Groundwater Application Review Summary Form

Application # G- 19048

GW Reviewer Halley Schibel/Travis Brown Date Re-Review Completed: 9/22/2022

TO: Water Rights Section Date 1/31/2022 9/22/2022
 FROM: Groundwater Section Halley Schibel/Travis Brown
 Reviewer's Name
 SUBJECT: Application G- 19048 Supersedes review of 1/31/2022
 Date of Review(s)

Water-Level Measurements in Nearby Wells

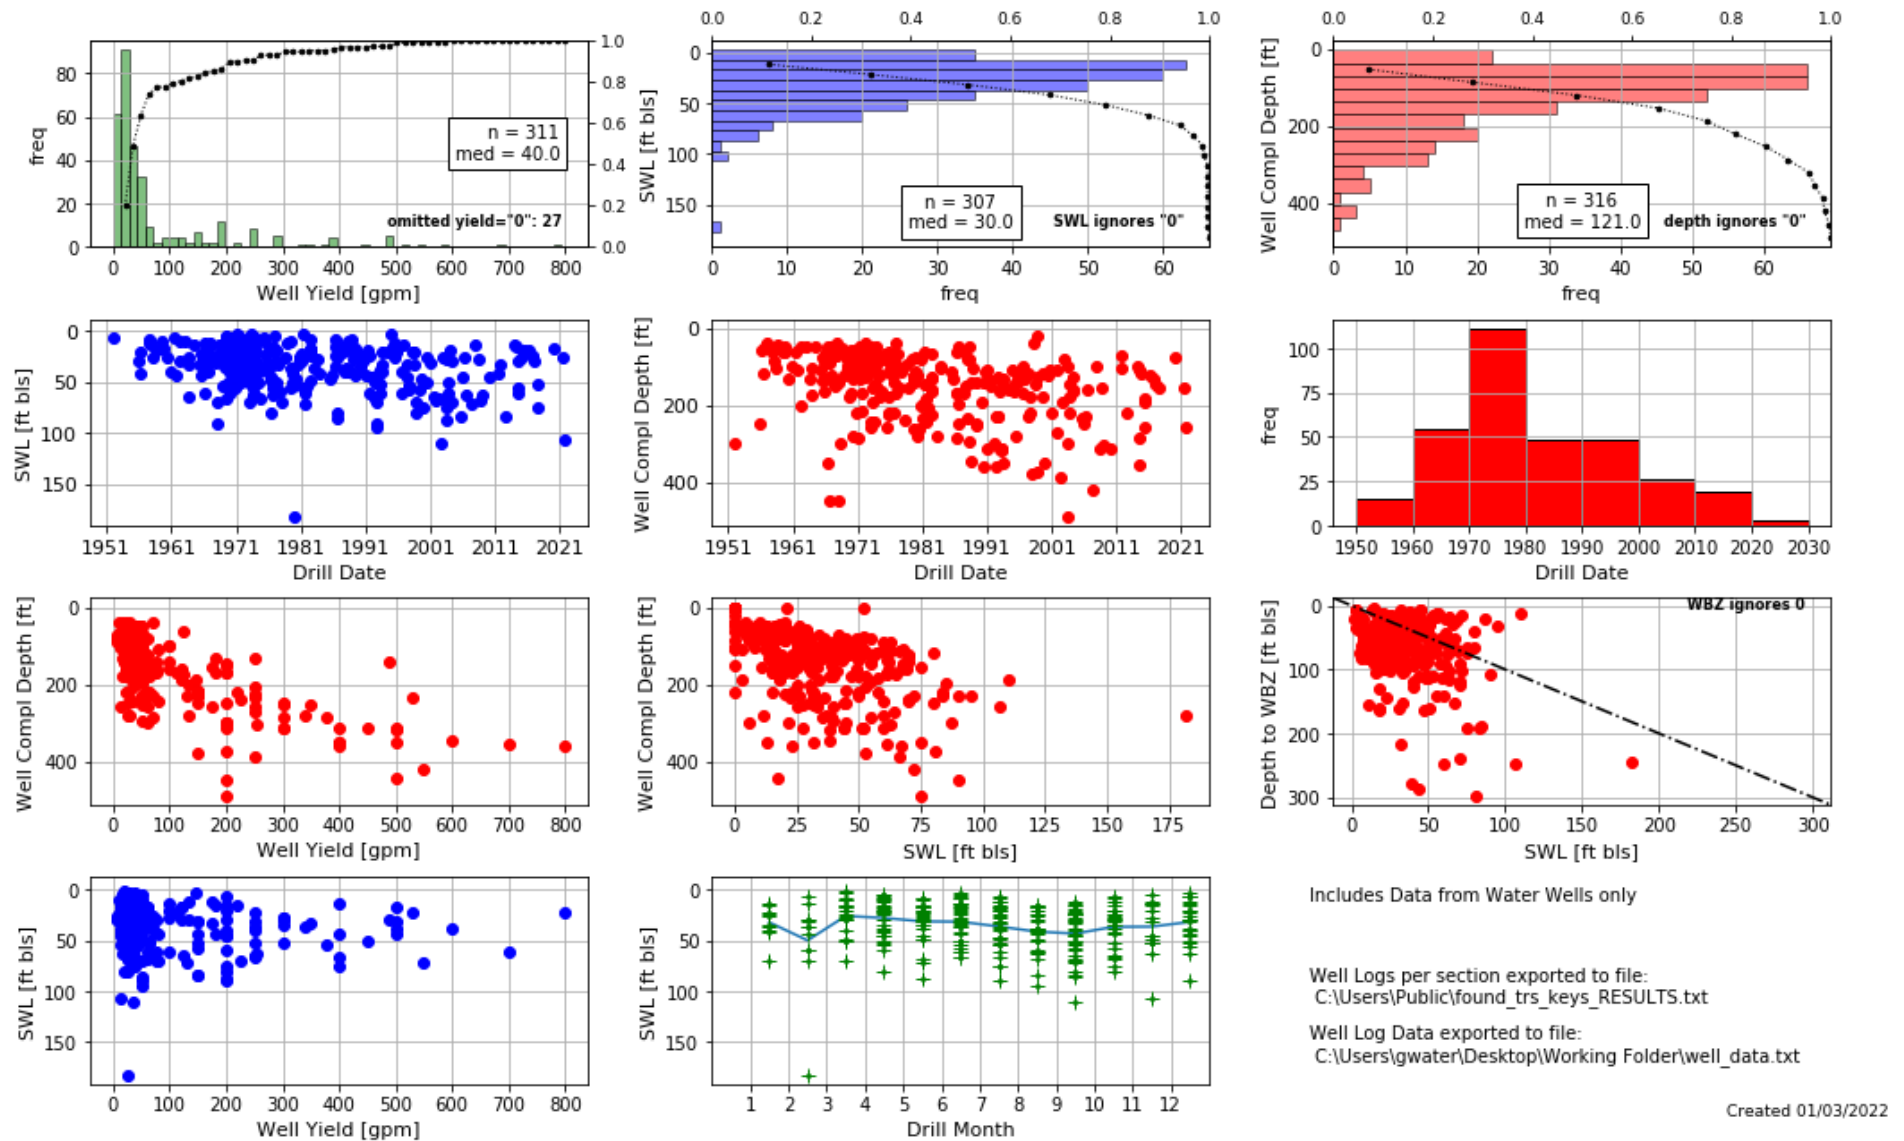
Nearby observation wells include wells on permits with static water level reporting conditions, which have measurements on record since the late 1990's and early 2000's. Neither the permit condition wells nor the longer-term state observation well data show excessive, area-wide declines.; aAlthough there seems to be a slight (+/- 5-ft) gradual decline seen in some wells shallower than 300-ft over the last decade, wells CLAC 12530 and 57287, which are closest to the proposed POA, show lower water levels only in the last 3-4 years, most likely because of lower precipitation – and, thus, lower recharge – during those years rather than over-appropriation (see attached Hydrographs).

In order to protect the groundwater resource and neighboring users, the conditions specified in B1(d)ii and B2(c), above, are recommended for any permit issued pursuant to this application.
